AP1000 DOCUMENT NO. APP-GW-GLR-134	REVISION 1	PAGE 1 of 470	ASSIGNED TO W-Sterdis	OPEN ITEMS (Y/N)
----------------------------------------------	----------------------	-------------------------	---------------------------------	------------------

TITLE: AP1000 DCD Impacts to Support COLA Standardization

AP1000 Standard Combined License Technical Report

AP1000 DCD Impacts to Support COLA Standardization

Figure 18.2-3

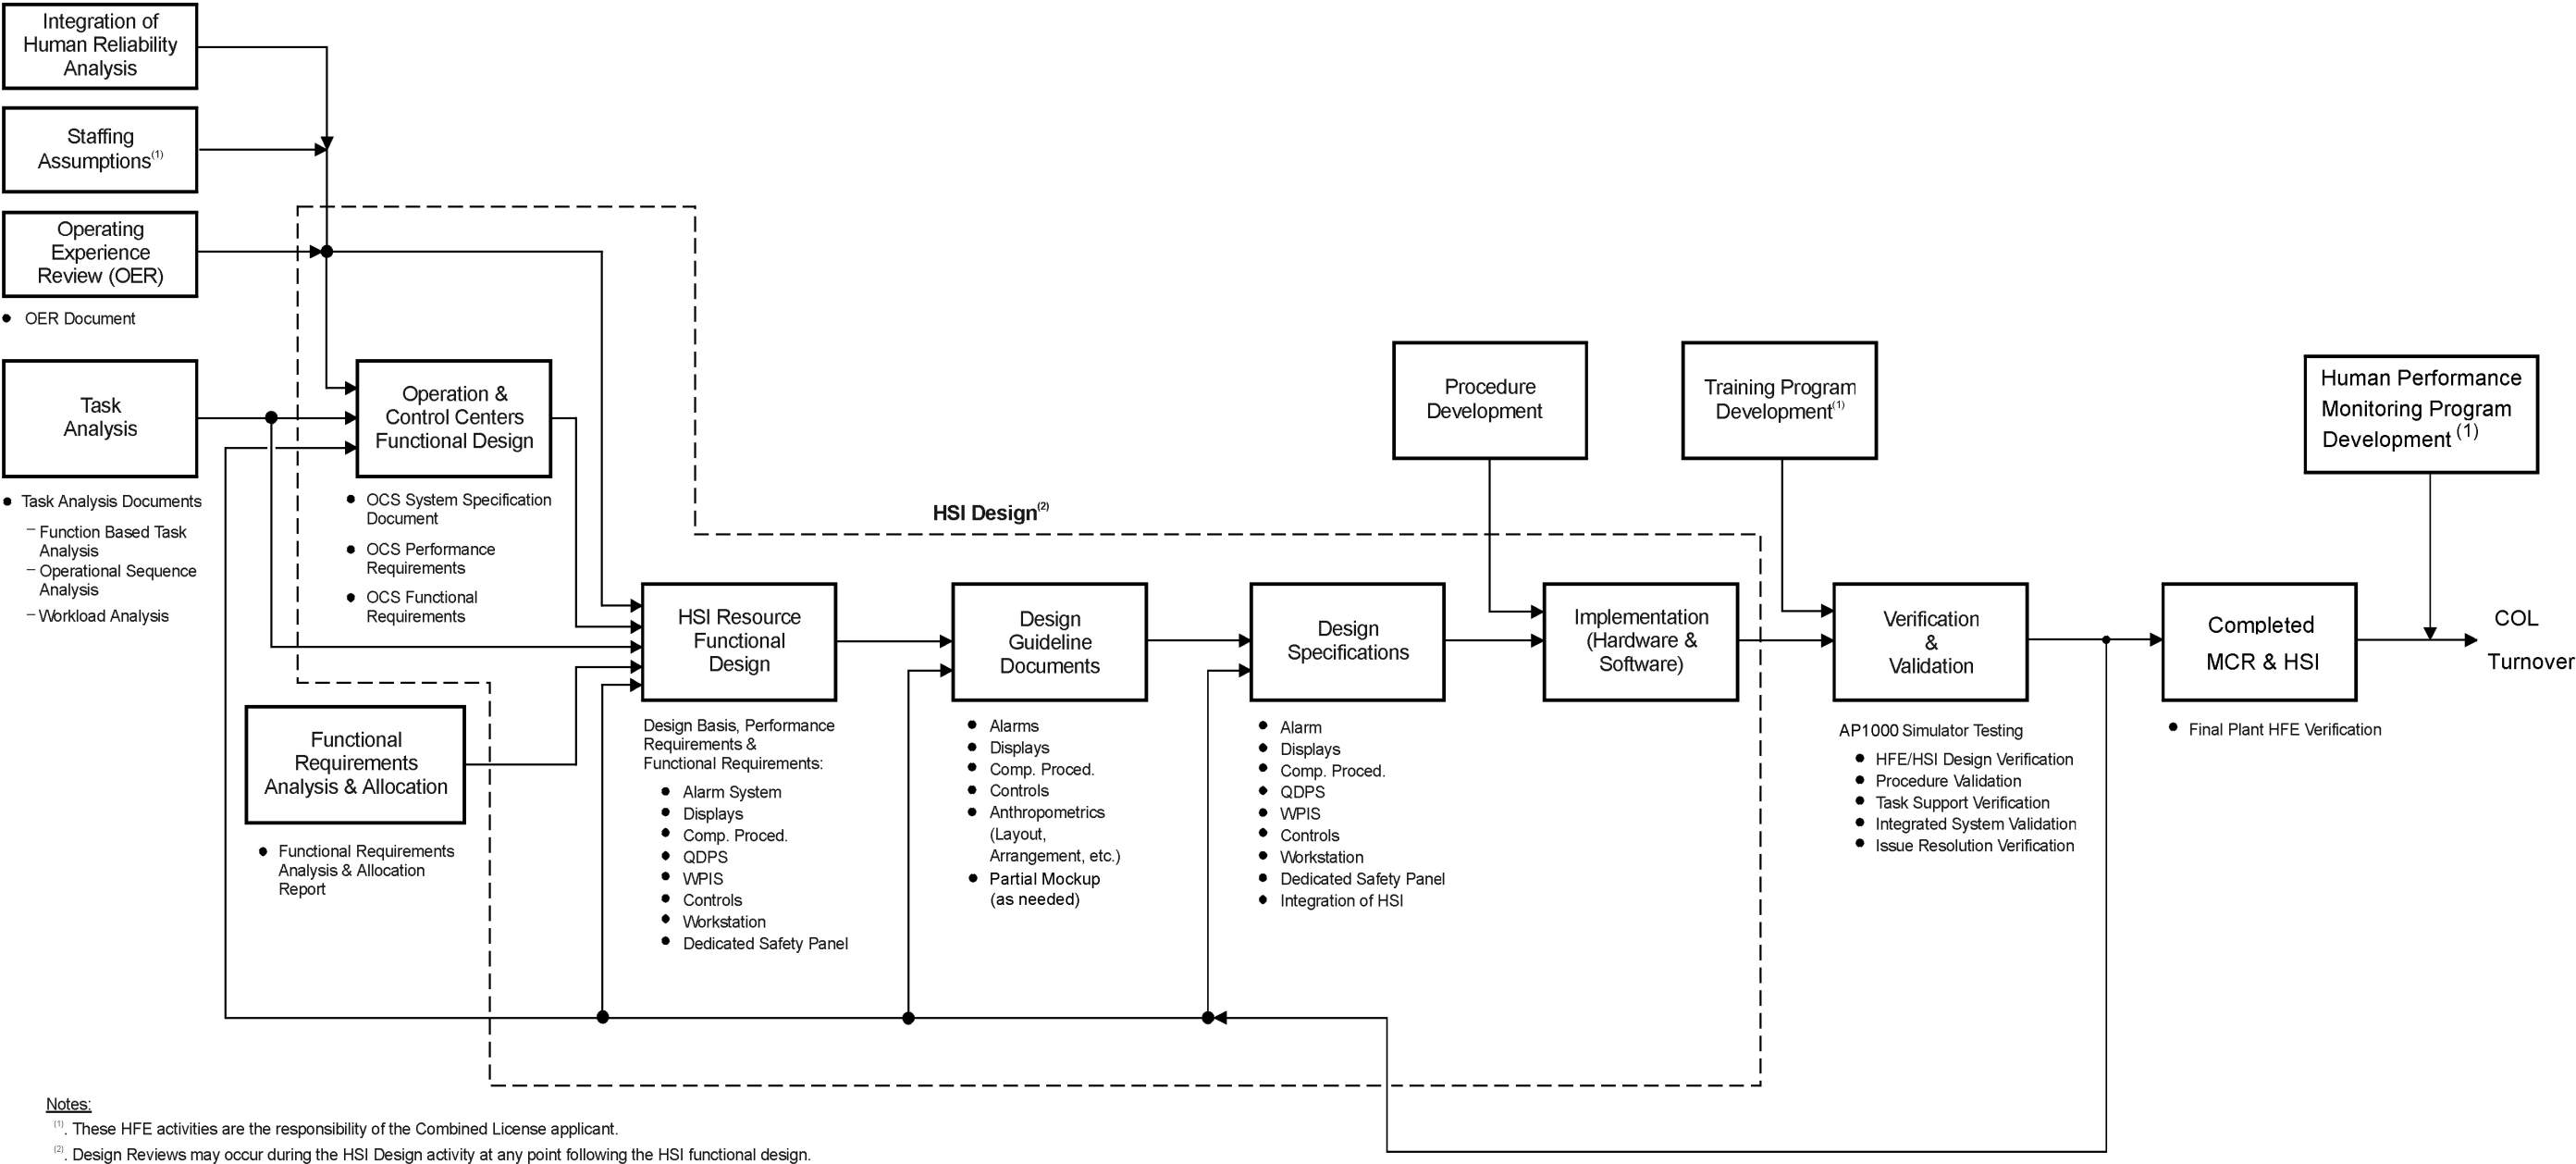
18.2	Accepted for Revision 17	NRC065	Tier 2	NRC Prior Approval Not Required
<i>Description:</i> NRC065 contains an editorial correction to delete the parenthetical reference to Note 1, (1), in the box containing the words "Procedure Development" on DCD Figure 18.2-3 The basis for this deletion is Revision 1 of Technical Report 70, APP-GW-GLR-040, which closes COL Applicant actions with respect to Operating Procedure development. In addition, this deletion will ensure that Figure 18.2-3 of the DCD is consistent with Table 1.8-2 which clearly states that, with respect to COL Information Item 18.9-1, there are no COL Applicant or COL Holder actions required.				
<i>Reference Information:</i> APP-GW-GLR-040 (TR70), Rev 1
